UNITED STATES PATENT AND TRADEMARK OFFICE

APPLICATION NO.	FILING DATE	FIRST NAMED INVENTOR	ATTORNEY DOCKET NO.	CONFIRMATION NO.
10/584,488	04/13/2007	Zhendong Wu	CCPT127661	6382

Office Action Summary	Application No. 10/584,488	Applicant(s) WU, ZHENDONG	
	Examiner ADAM MARCETICH	Art Unit 3761

DETAILED ACTION

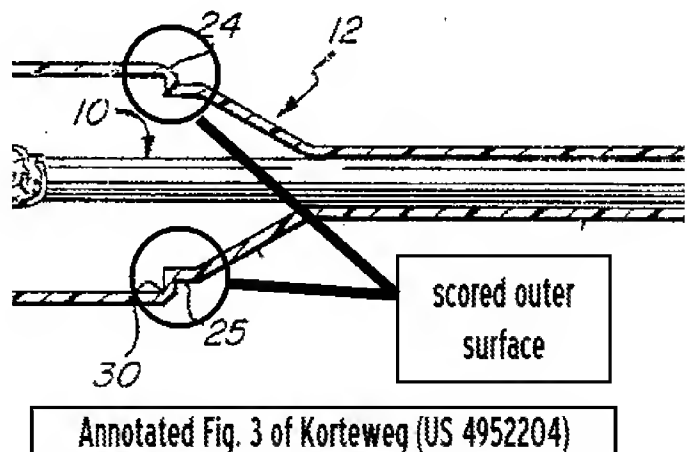
wherein the easy break-off mark is scored on an outer surface of the tube-like container around the circumference of the tube-like container (col. 2, lines 39-44, Rowe incorporates Korteweg; Wayne US 4952204 by reference, which discloses at (cols. 3-4, lines 60-4 a narrow annular component 24 depicted as external scoring; see annotated Fig. 3 of Korteweg);

15. Applicant contends that frangible casing 18 of Rowe is an entire section of the outer casing 12, instead of the claimed thin score. Examiner cites Korteweg as teaching a thin score, as depicted in annotated Fig. 3. To clarify, Examiner interprets the concave or sunken portion near element 24 as analogous to the claimed break-off mark.
